## JOINT REGIONAL PLANNING PANEL

<b>Development Application No.</b>	➤ D/2012/429
<b>Address</b>	➤ 118-124 Terry Street, ROZELLE NSW 2039 comprising Lot 3 in DP119 Section D, Lot 2 in DP 234045 and Lot 1 in DP540118.
<b>Description of Development</b>	➤ Demolition of all existing buildings, remediation of the site, construction of a mixed use development comprising 202 apartments, 1270sqm of retail/commercial space, 411sqm of light industrial space operating as live/work units, 250 car spaces and subdivision. A new road will be constructed within the site and dedicated to Council. The proposal also entails construction of a temporary sales office with display units and signage.
<b>Date of Receipt</b>	➤ 7 September 2012
<b>Value of Works</b>	➤ \$80,000,000
<b>Applicant's Details</b>	➤ ANKA Constructions Pty Ltd Andrew Boyarsky C/- ANKA Property Group PO BOX 727 EDGECLIFF NSW 2027
<b>Owner's Details</b>	➤ ANKA Constructions Pty Ltd Level 3, 179 -191 New South Head Rd EDGECLIFF NSW 2027

<b>Main Issues</b>	➤ Traffic, parking, interface with public domain, streetscape, pedestrian safety, stormwater management, amenity of neighbouring properties.
<b>Recommendation</b>	➤ Deferred Commence

*(Detail – stepped landscaping/walling treatment between Terry Street footpath and proposed apartment building C)*

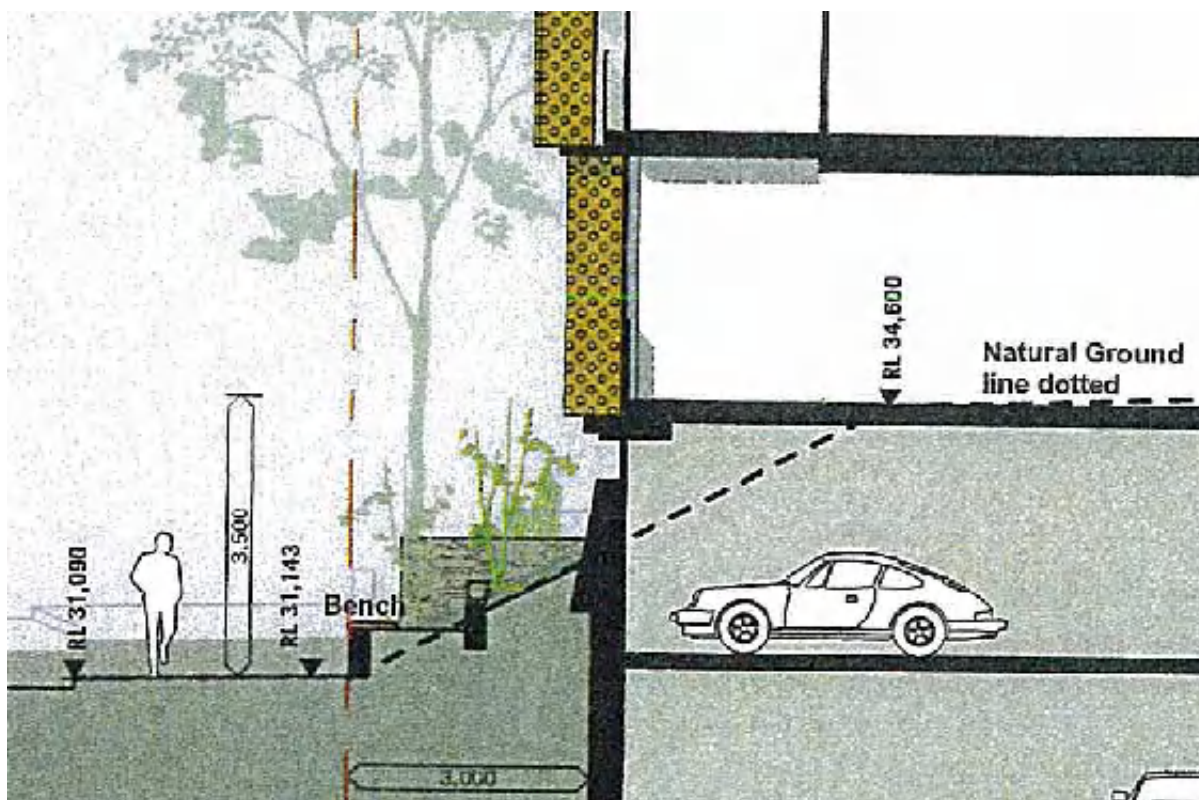
Advice from AJC suggested that this ramped wall would inter-relate better with the public domain if it was redesigned as a stepped terrace, landscaped with terrace gardens, and terminating at street level with a series of stone walls, some of which, where levels permitted, should be low enough to function as street benches.

Council concurred with this advice, and informed the applicant that such redesign needed to be incorporated into the proposal. The latest set of documents have achieved this, as shown below.

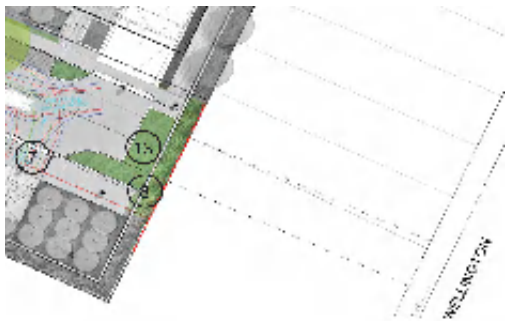
Comment: · The minutes of the Ordinary Council meeting of 19 April 2011 do not actually state that references to “future road” or similar nomenclature would be abandoned. The Minutes state as follows:

*(Section indicating levels relationship between New Road and 11A Wellington Street)*

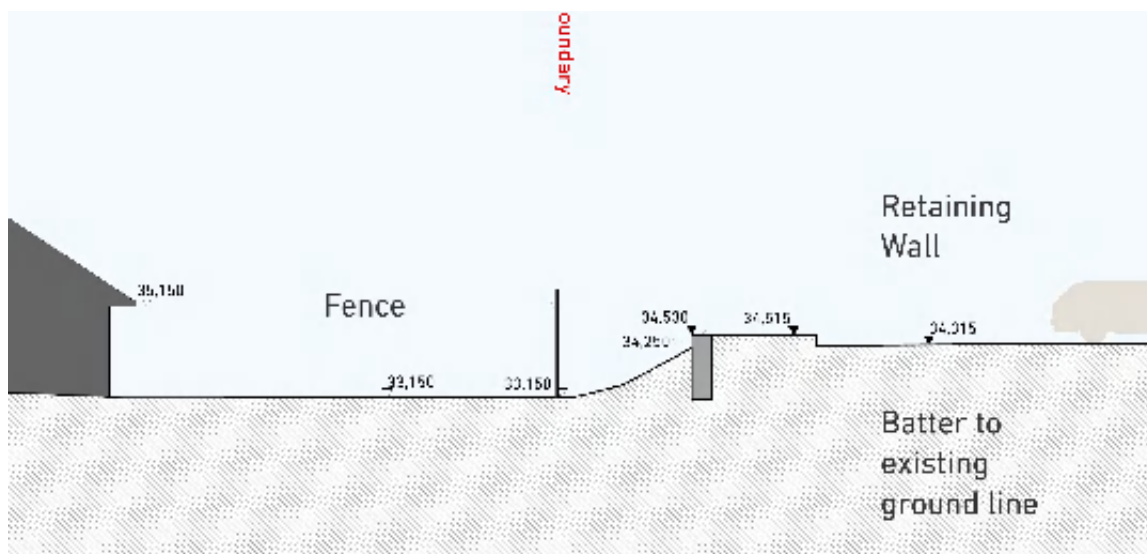
Comment: The submitted landscape plans show “13 - temporary landscaping pending future road works” in this location, as below

Council recommends that the landscape planting and fencing in this location be sufficient to protect the privacy and security of the residents of the adjoining Wellington St properties, due to the proposed levels and change in nature of use of this area (see figure below for demonstration – the fence measures at 2.4m high however notwithstanding this a 1600mm eye height from a person standing at the end of New Road would allow viewlines into the rear of the neighbours building).

A suitable condition is therefore recommended to require landscaping between the retaining wall and the fence line.
